Handling absence of data lock in Idle Insertion State Machine

Jeff Mandin - PMC-Sierra
802.3av TF – Vancouver
March 2009

Revised Figure 76-24

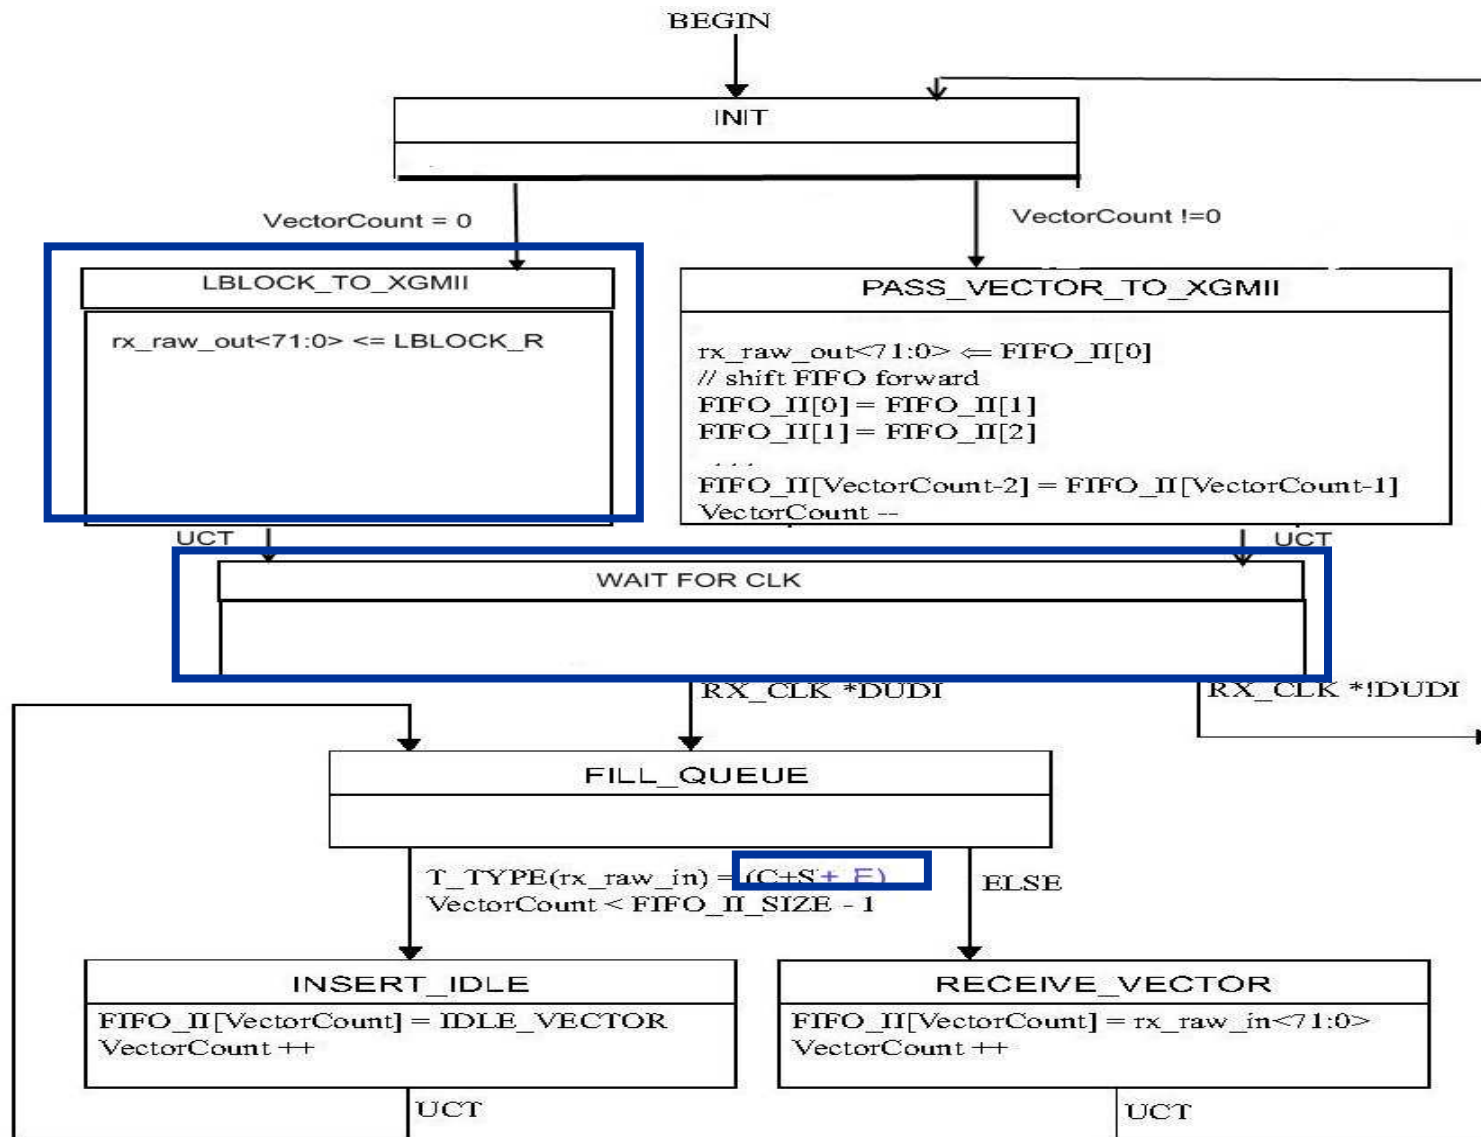
Add definition to Constants (76.3.3.7.1)

LBLOCK_R

This constant is defined in **49.2.13.2.1**
